Re: Welby Junction: Written Explanation Planned Unit Development/Preliminary Development Plan & Preliminary Plat Application

Thank you for the pre-app comments, received July 19th, 2024. We have reviewed all comments and addressed them in this letter. Please feel free to contact me directly should you have any comments, questions and/or requests for additional information. We look forward to continuing to work with the city to make this new community a success.

PLANNER REVIEW

SHEET 4: CONNECTIVITY AND OPEN AREA PLAN

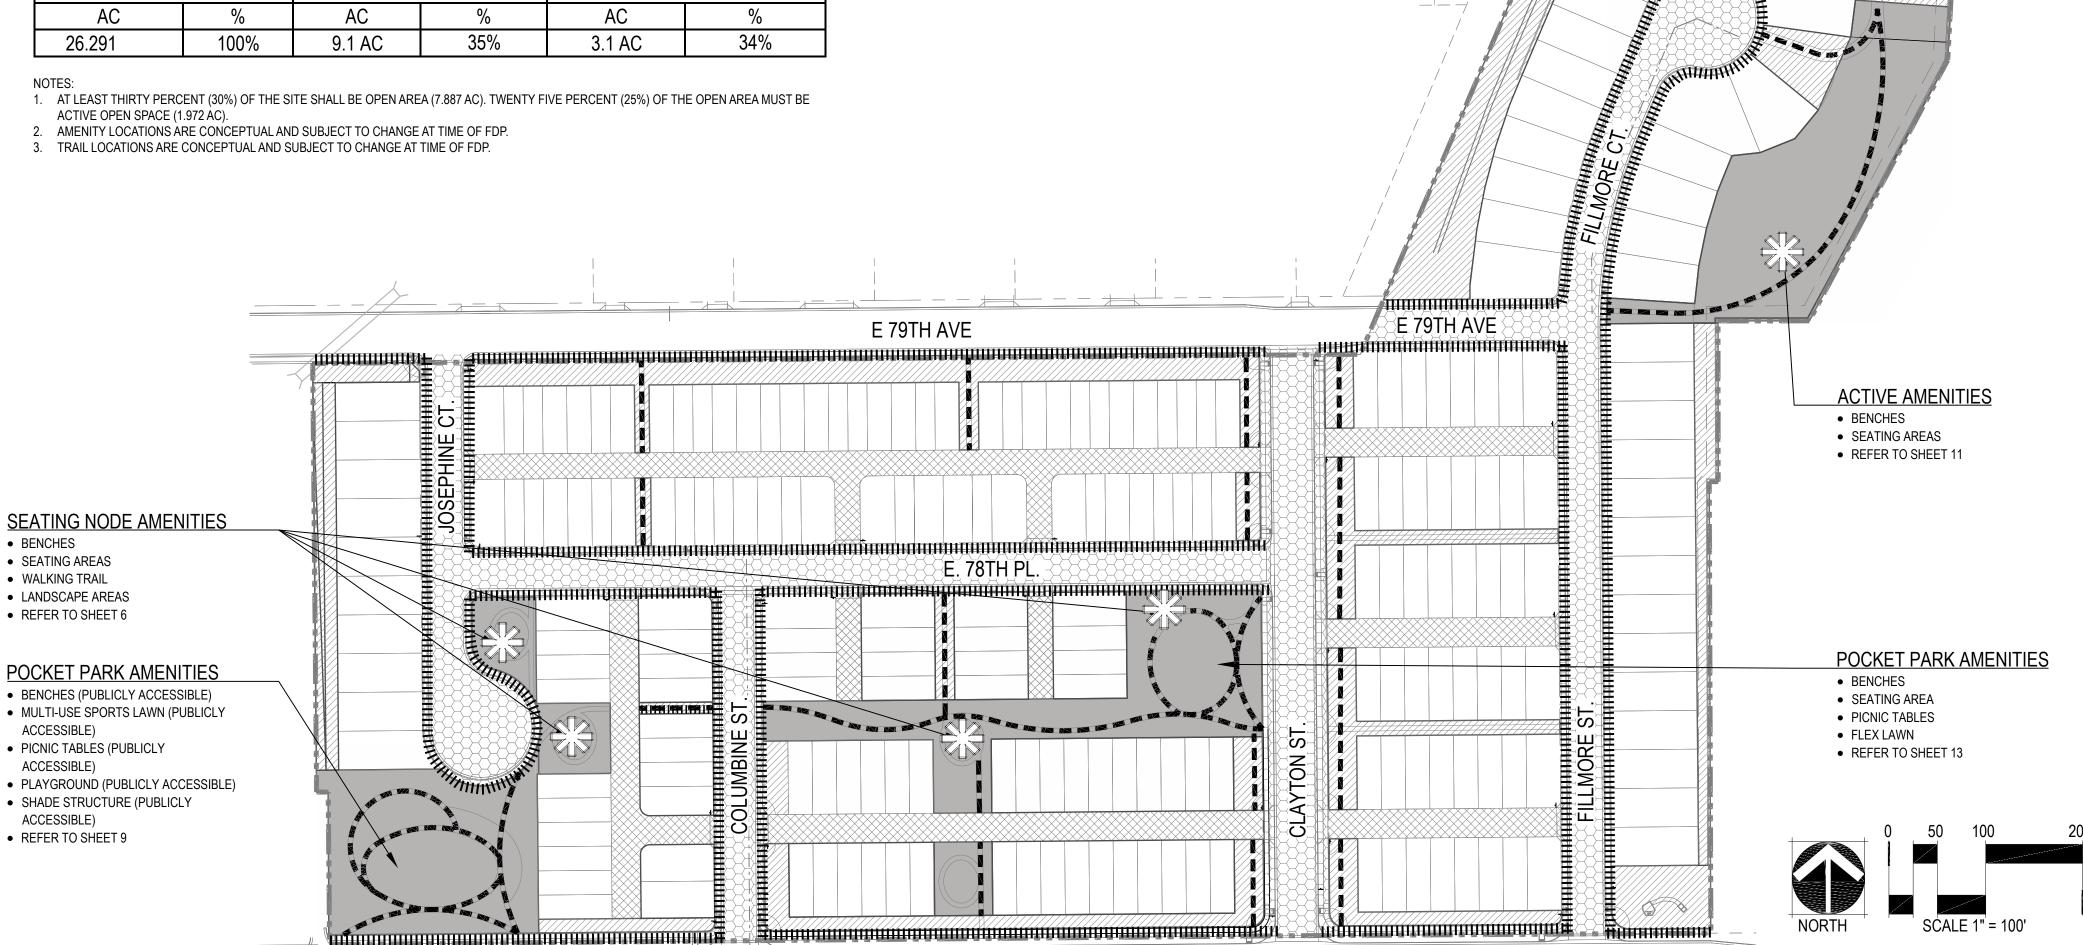
- D. PLNO4: Although the overall layout being proposed in similar to the previously approved PDP, the active recreation space appears to be considerably different. Based on the final plat that was withdrawn, the site area is 26.3 acres. 30% of the site (7.9 acres) should be designated for open space. Of that 7.9 acres of open space, 25% of the open space lands (2 acres) shall be used for active recreation. Please review the County's definitions for "open space" (in Section 11-02-437) and "active open space" (in Section 11-02-438) to ensure that planning the park areas is consistent with County regulations. It is the expectation of the Community & Economic Development Department that the active recreation space will be utilized for the enjoyment of people, and the amenities will be something that people can enjoy throughout large portions of any calendar year.

Response: This plan provides appx. 9.1 acres (35%) of open space with appx 3.1 ac (34%) of active open space, meeting the requirements for PUD open space. Refer to sheet 4 of the PDP for open space calculations and anticipated amenities.
